**Review of the design for the
proposed alterations and
additions to the parking
garage of the dwelling house
at 42 Upper Clifford Avenue,
in Fairlight, NSW**

Traffic Engineering Review

DA2020/0706

Figure 2.1

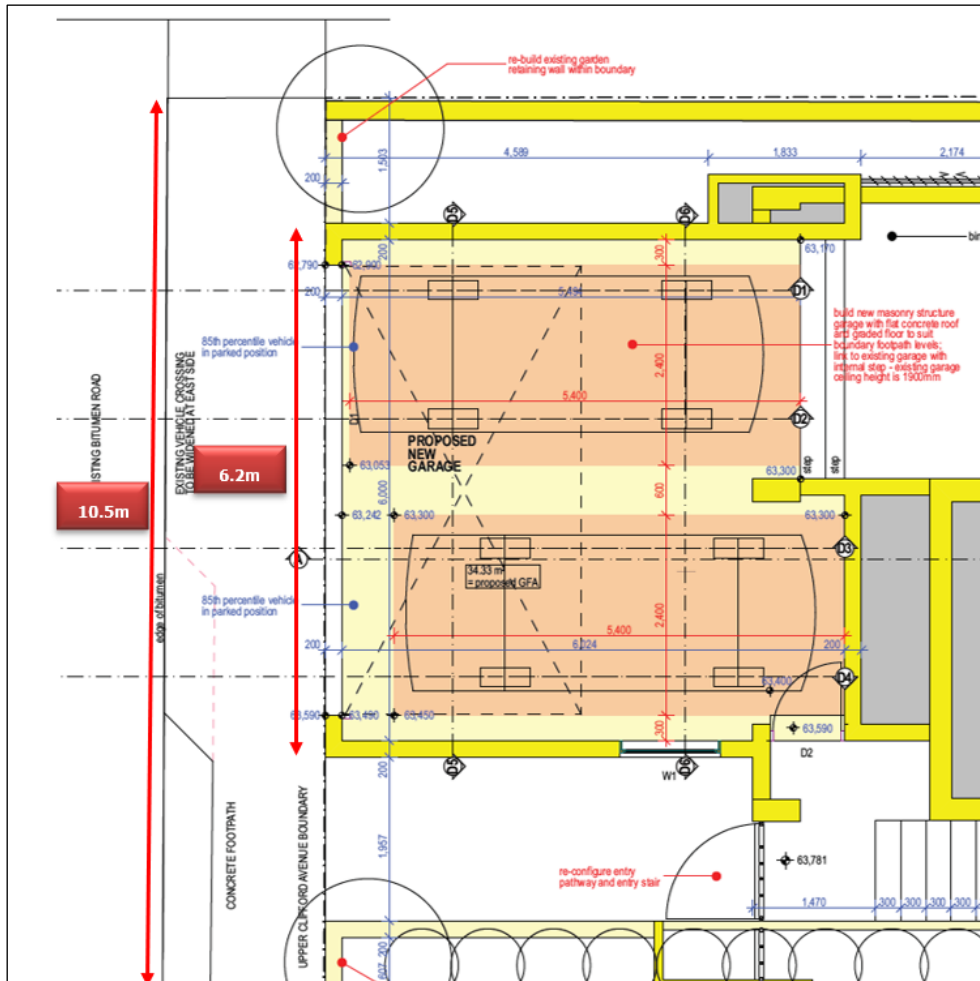
As measured on the scaled design plans, the width of the parking garage is 6.2m wide (refer to Figure 2.1), which **complies** with the **paragraph (c)**. However, as the frontage is 10.5m wide (refer to Figure 2.1), it means that the garage does exceed, by approximately 9.5%, a width that equalise 50 percent of the frontage, which makes it **non-compliant** with the **paragraph (c)**.

Figure 2.2: The proposed 90-degree angled parking space

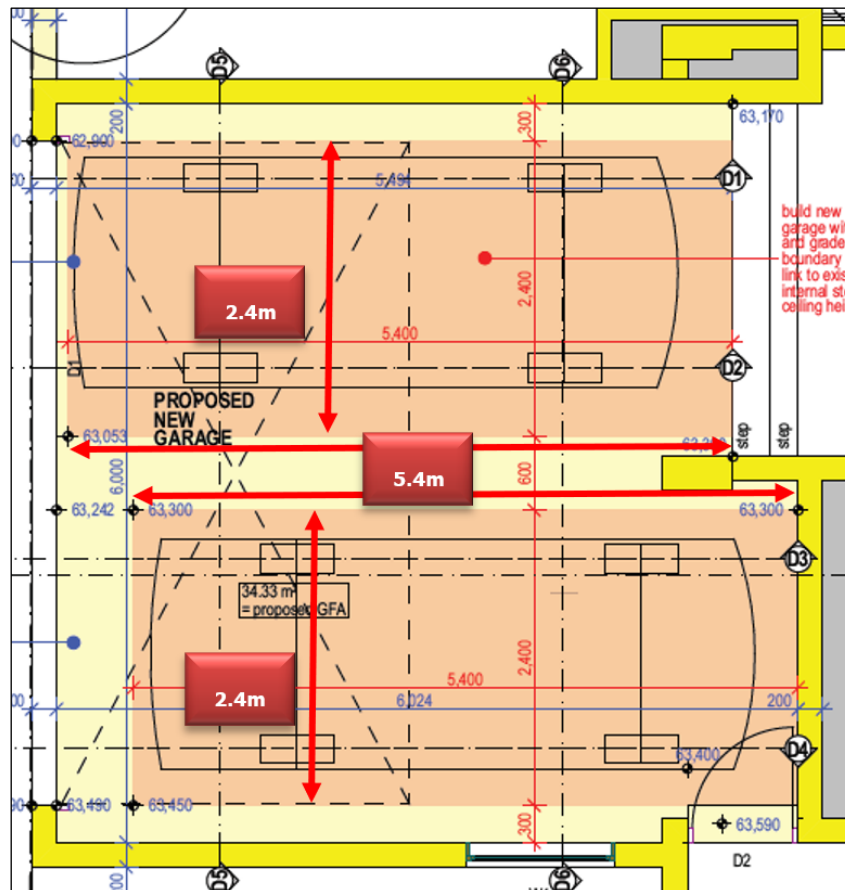
Dimensions of the proposed 2 (two) 90-degree angled parking spaces parking spaces were measured [on the scaled plans] and calculated to be 2.4m wide and 5.4m long (refer to Figure 2.2).

The proposed parking space fully complies with the minimum spatial requirements for the parking envelope as required per the AS 2890.1:2004 (5.4m x 2.4m for a 'residential' or 'domestic' parking space – refer to Tables 2.1 & 2.2).

Conclusion: Based on the dimensions shown on the design drawings, we are of opinion that the dimensions of these 90-degree angled parking spaces fully comply with the minimum spatial requirements for the parking envelope, as per AS 2890.1:2004.

Figure 2.3: Vehicular-crossing's width
 (Source: Stewart Design Studio)

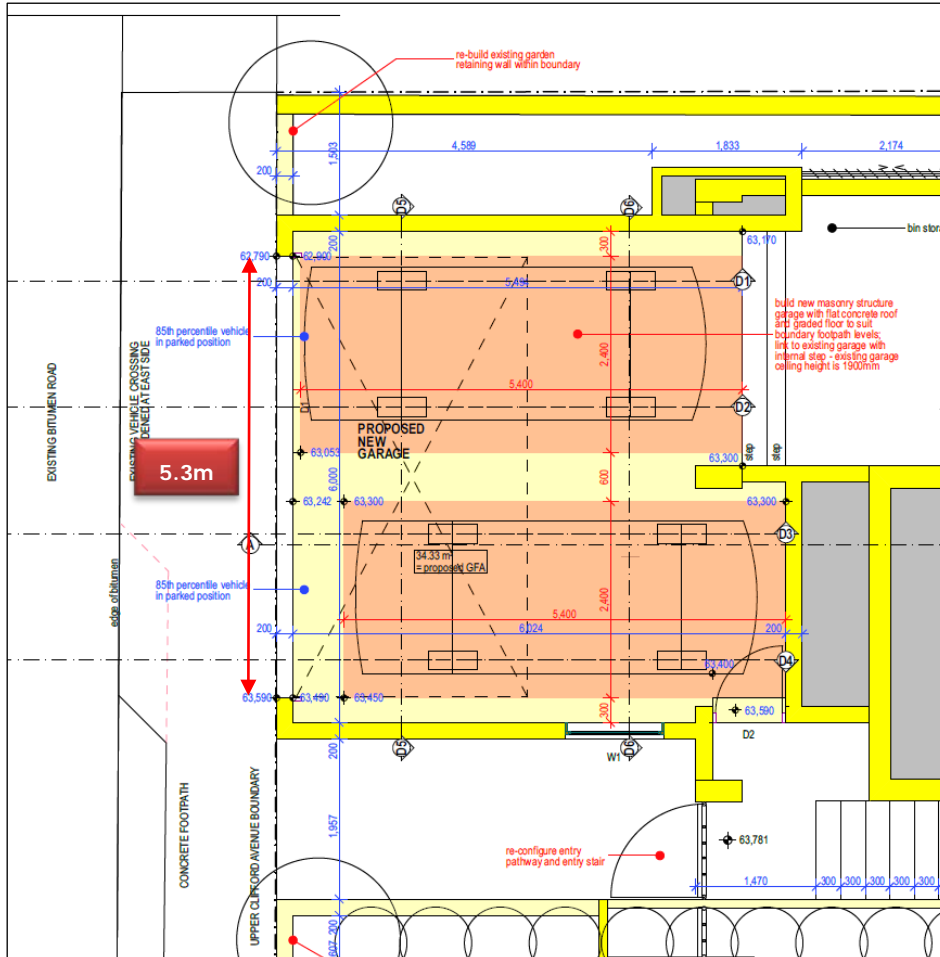
The **vehicular crossing** is measured [on the scaled plans] and calculated to be 5.3m wide (refer to Figure 2.3), thus it fully **complies** with the minimum standard requirements for access driveway width of 3.0m for the class of parking facility '1A' ('residential' and 'domestic') as per AS 2890.1:2004 (refer to Tables 2.3 & 2.4).

Conclusion: Based on the measurements, undertaken on the provided scaled plans, we are of the opinion that the access driveway/vehicular crossing width fully complies with the standard requirements as per AS 2890.1:2004.

Figure 2.4: Gradient

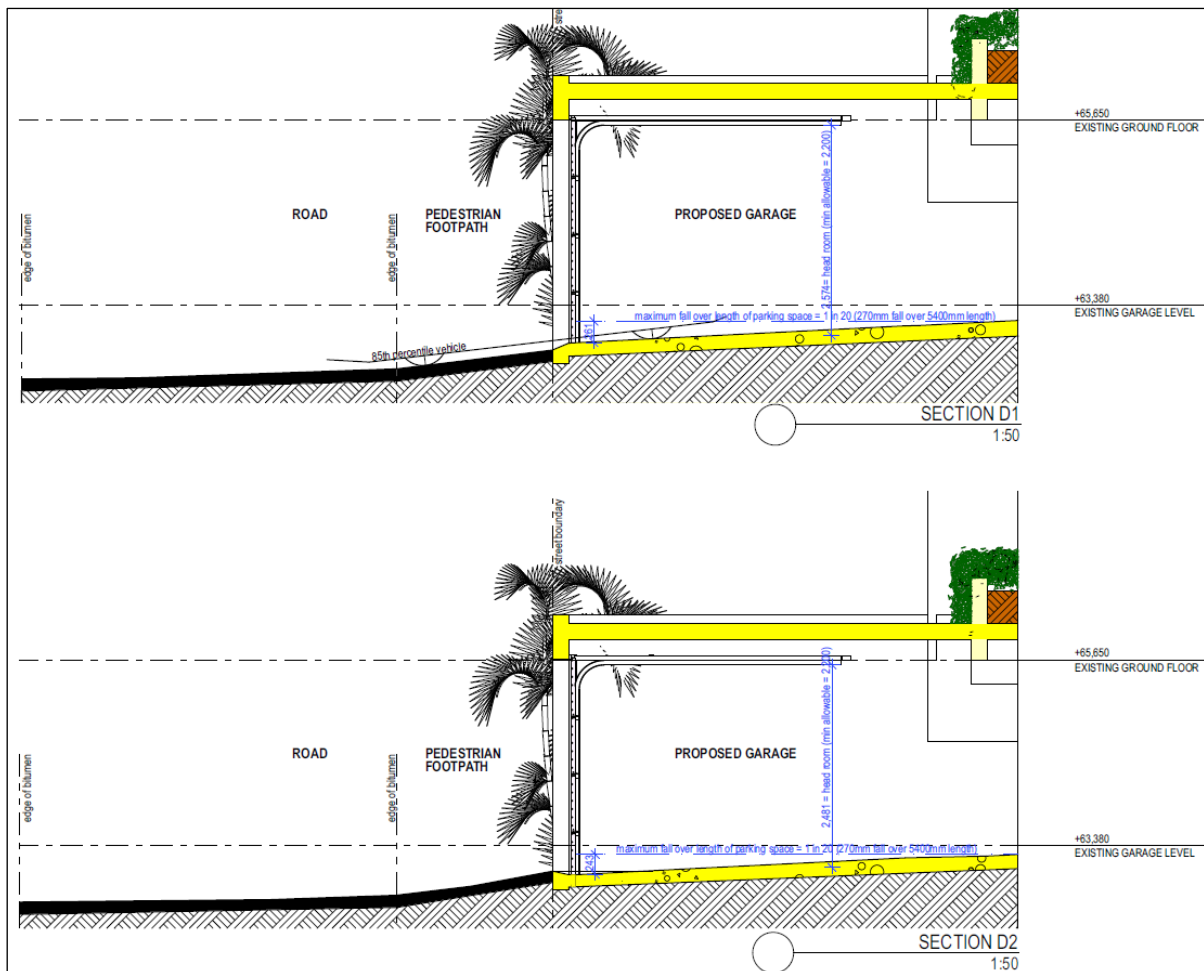
According to the design for the longitudinal surface profile of the proposed driveway (refer to Figure 2.4), we are of the opinion that both the proposed parking spaces (with the gradient of 5% - 270mm fall over 5400mm length) do comply with the standard requirements, as per AS 2890.1:2004.

Conclusion: Based on the measurements undertaken on the provided scaled plans, we are of the opinion that the access driveway and the garage width fully comply with the standard requirements as per AS 2890.1:2004.

Figure 2.5: Detail Street Elevation Garage

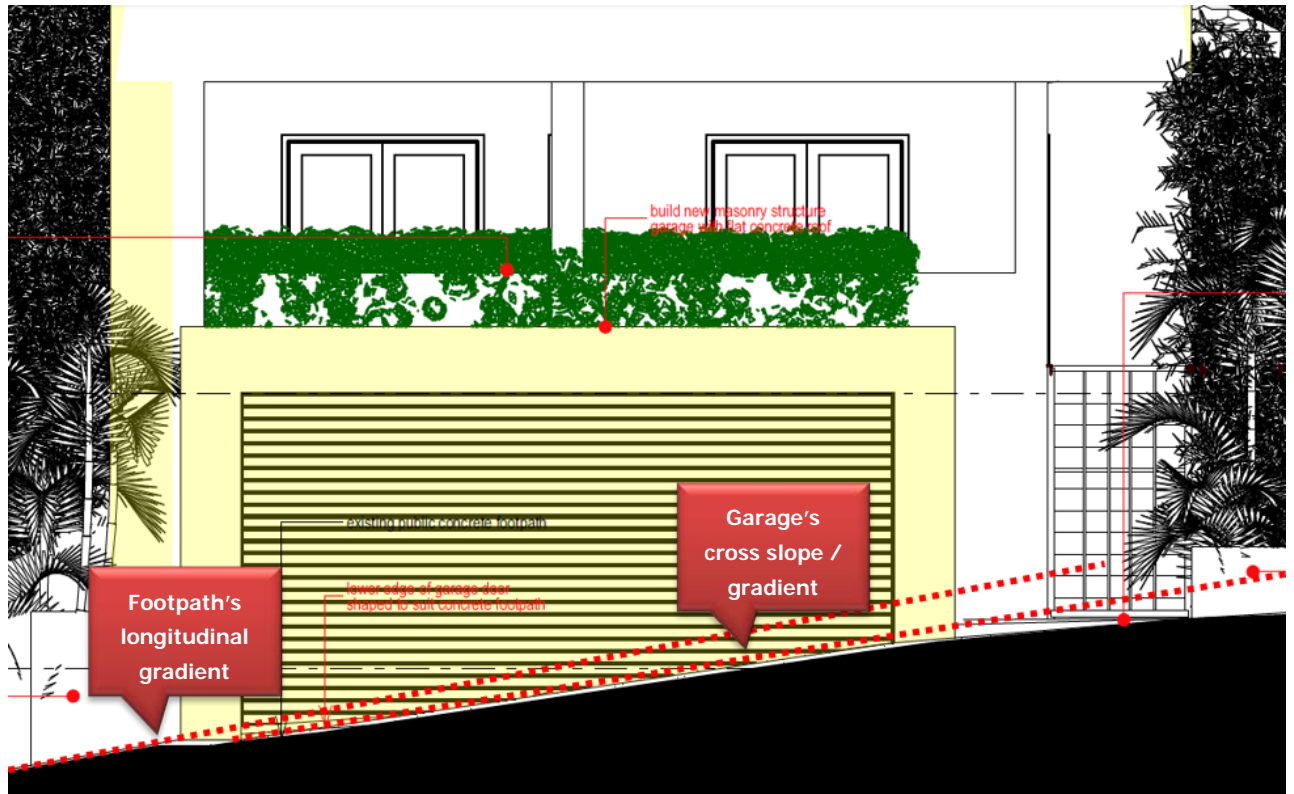
While, seemingly, the proposed cross gradients of the parking garage and the longitudinal gradient of the adjacent footpath are seemingly the same or at least very similar (as they appear to be parallel - refer to Figure 2.5), there is nothing in AS2890.1:2004 to indicate what is the required cross gradient of a driveway for a parking garage.

The Standard AS2890.1:2004 only indicated the minimal longitudinal gradients of domestic driveways and not their cross gradients.

Conclusion: Based on the measurements undertaken on the provided scaled plans, we are of the opinion that the cross gradient of the access driveway/garage and the longitudinal gradient of the adjacent footpath, comply with the standard requirements as per AS 2890.1:2004. At least, the AS2890.1:2004 contains no paragraph or requirements to suggest otherwise.
